**SUBJECT: CONDITIONAL USE / CLASS 3 SITE PLAN REVIEW / CLASS 2 DRIVEWAY APPROACH PERMIT / CLASS 1 DESIGN REVIEW CASE NO. CU-SPR-DAP-DR22-07
2410 FAIRGROUNDS ROAD NE - 97301
AMANDA NO. 22-117397-PLN**

Summary: Phased development of a motor vehicle sales use and motor vehicle services use, with vehicle display and vehicle storage areas.

Site Plan Review Class 3
 Creative Credit & Auto Sales
 2410 Fairground Rd NE

WAREHOUSE BUILDING SOUTH ELEVATION
C
A32 SCALE : 1/16" = 1'-0"

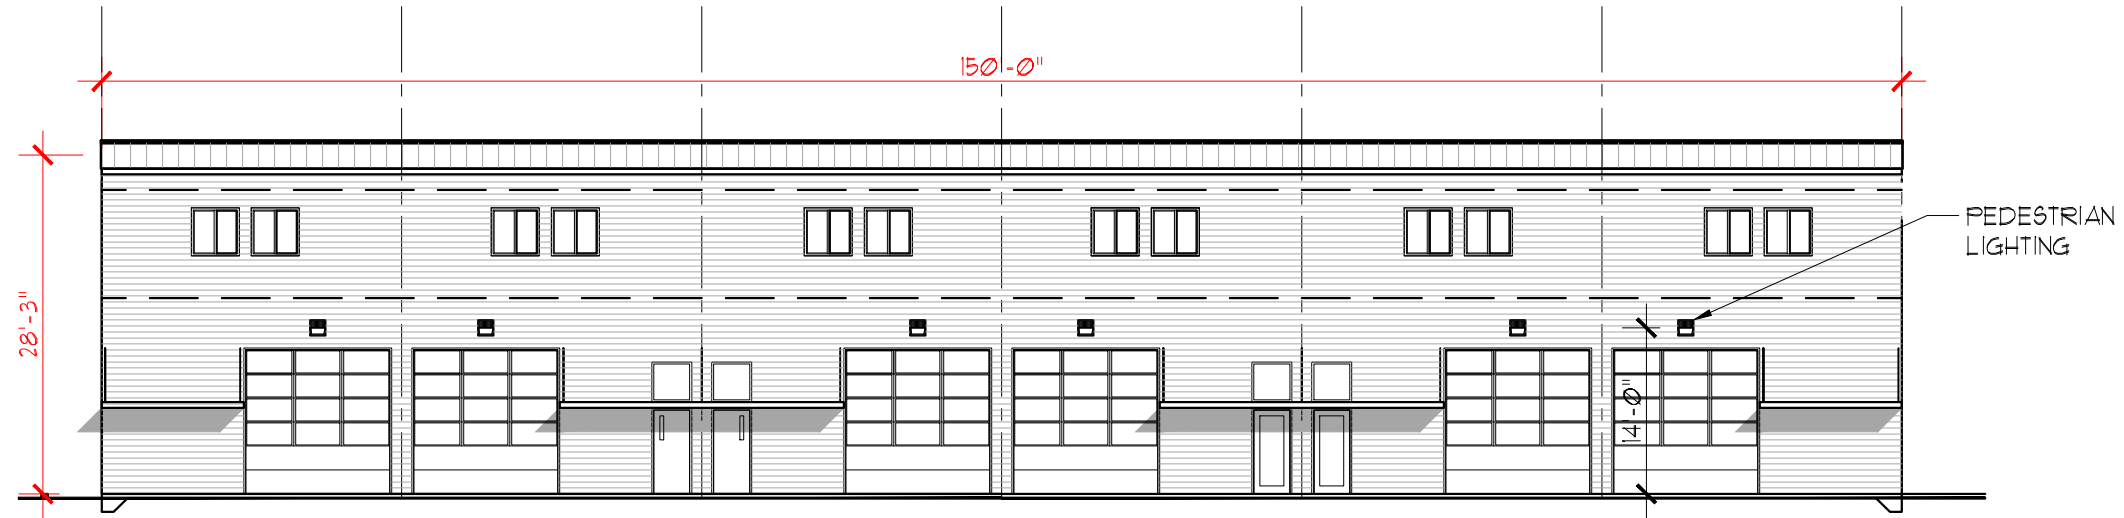
The building in Phase 2 has approximately 325 feet of sidewalks and pedestrian connections abutting the building façades. The elevation plan indicates that awnings or canopies will be provided above approximately 115 feet (35.4 percent) of the adjacent walkways, which does not comply with the minimum standard. Additional awnings or canopies will need to be provided above adjacent sidewalks and pedestrian connections.

- Condition 10:** Weather protection, in the form of awnings or canopies, shall be provided along a minimum of 50 percent of the length of the ground floor building façade adjacent to sidewalks or pedestrian connections for the proposed building in Phase 2.

See revised South building elevation C/A3.2. Awning is 25 feet long (50% of the length of the ground floor), and 8 feet above the pedestrian connection.
